CITY OF MINNETONKA
PLANNING COMMISSION
OCT. 26, 2023

**Planning Commission Agenda
Oct. 26, 2023
6:30 p.m.**

Brief Description Amendment to the sign plan for Ridgehaven Mall at 13145 Ridgedale Drive.

Figure 1 - Tree Removal Plan

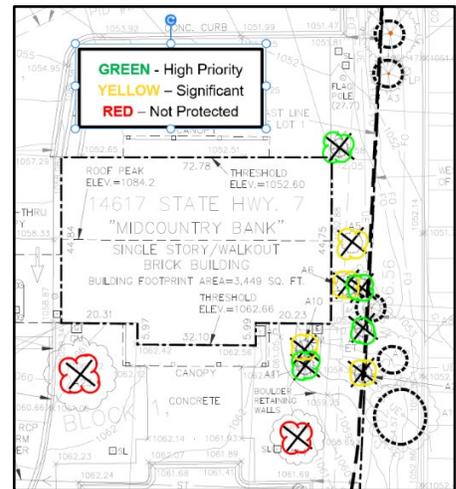
Based on the location of the protected trees, it would be extremely difficult to remove the existing ones and meet the tree protection ordinance.

Based on discussions with the applicant, there is no alternative plan where the existing building could be removed and the number of tree removals reduced.

Figure 2 - Site circulation and bypass lane

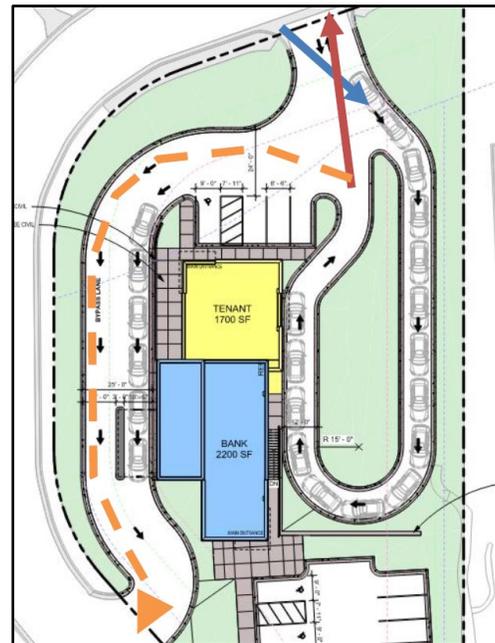
The traffic consultant provided one comment concerning potential circulation issues at the site.

Vehicles entering the northern access for the restaurant would need to head immediately left, which would conflict with vehicles exiting the site. (Shown in blue and red on Figure 2.) Operational impacts are expected to be minimal. However, if safety issues arise, a condition of approval would allow the city council to reasonably add or revise conditions to address any future unforeseen problems.

Figure 2.) Albeit the proposal is reasonable, staff agrees that the bypass lane should be removed from the site plan.

1. Minimal internal circulation is expected in this area related to the bank use. The bypass lane would create unnecessary added internal circulation from users leaving the restaurant queue.
2. Vehicles existing on the western access have a slightly obstructed view of traffic coming from the east on the South Service road due to the curvature of the road. Traffic should be limited to bank users to mitigate potential traffic conflicts.
3. Removing the bypass lane would allow the site to meet the parking lot setback requirement from the ROW.

The removal of the bypass lane has been added as a condition of approval for this project.
